REF: CS / MS61700 3854 / RIGBER

VEHICLE DAMAGE INSPECTION REPORT

Insured/Claimant:	PAN OCEAN INTERNATIONAL PTE LTD	Policy No:	A28712860MKC	Claim No:	505605
Date of Loss:	13/02/2017	Nature of Claim:	OD

Reg No:	XE6006J	Engine No:	OM457319642
Make & Model:	MITSUBISHI FP51SDR3VDEA, 12.0 D (M)	Chassis No:	FP51SDA20027
Reg. Date:	22/03/2016 (Man. Year: 2015)	Odometer:	0 km
Colour:	Brown		
Engine Capacity:	11967 cc		
Market Value/New Car Price:	S\$130,000.00		
Sum Insured (\$\$):	Market Value/New Car Price

Photo 92 to 94 - Steering Shaft bent, during re-inspection checked.

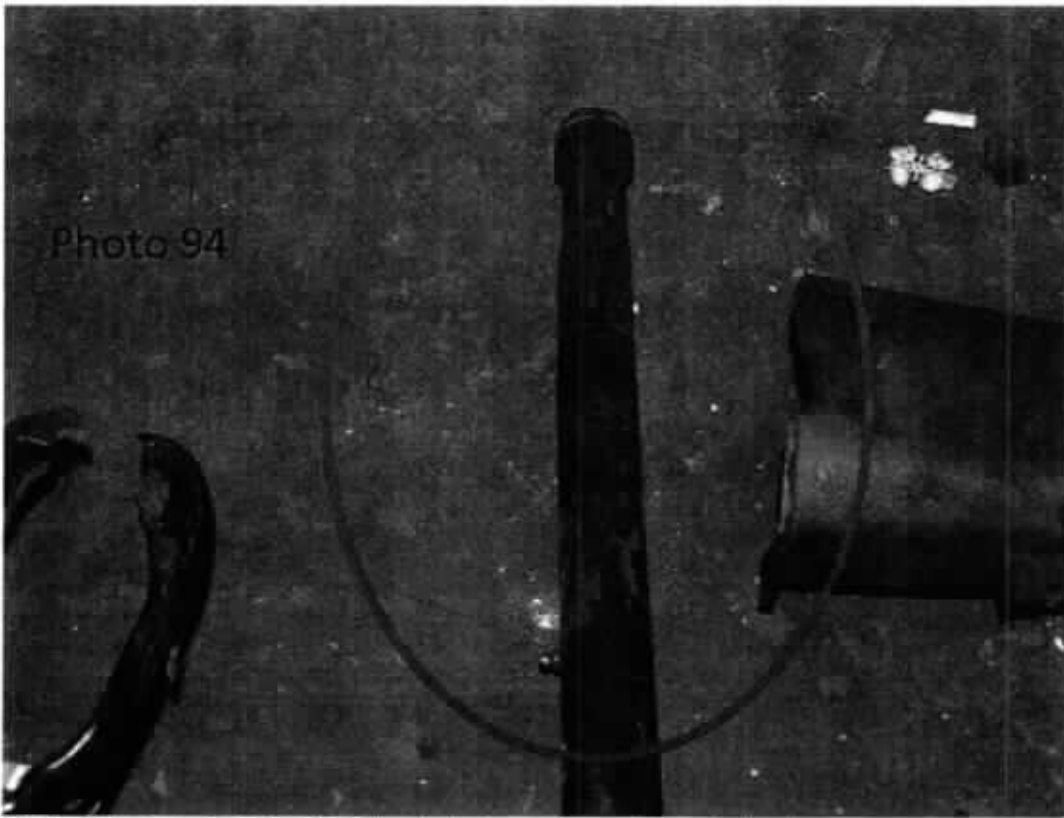
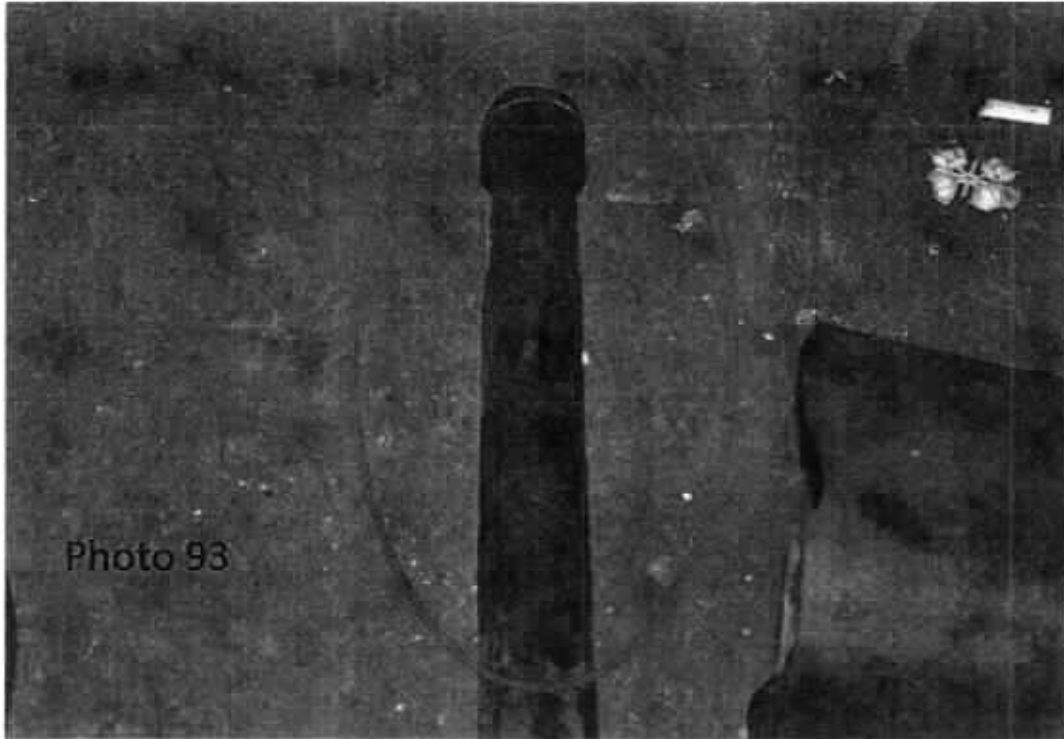
Maintained: Hi Surveyor at LKK. Thanks for the re-inspection photos. We have two more questions: 1) How do you determine the steering shaft was damaged? Were there any photos taken before dismantling the steering shaft? 2) What do photos number 45—

Maintained: Hi Surveyor at LKK, please let us have more photos showing damages to steering shaft, combination clock spring switch, rear quarter panel outer RHS, front wheelhousing liner RHS, dashboard and the undercarriage parts. Thanks,

Hi Surveyor at LKK. Thanks for the re-inspection photos. We have two more questions: 1) How do you determine the steering shaft was damaged? Were there any photos taken before dismantling the steering shaft? 2) What do photos number 45 to 49 trying to indicate/show? Please advise. Thanks.

We refered to Mr K. K. Lau
explanation at your good office this
afternoon. The damages to the
steering shaft and related were
due to the "induced damage"
as the a results of impact at
the cabin & floor board panel.

1) The damage was on the front RH portion. The damages was on the steering linkages side near to the driver side. Due to the impact, possibility the steering shaft will bend.

2) No photos were taken before dismantling the steering shaft.

2) During the physical inspection, I observed the steering wheel by turning it left or right, found irregular movements, ± for the checked & looked at the underneath it was damaged,

Shoot picture
unable to get a close-up due to
blockage. (See photos 66)
However, during the reinspection confirmed
it was bent & beyond repair.
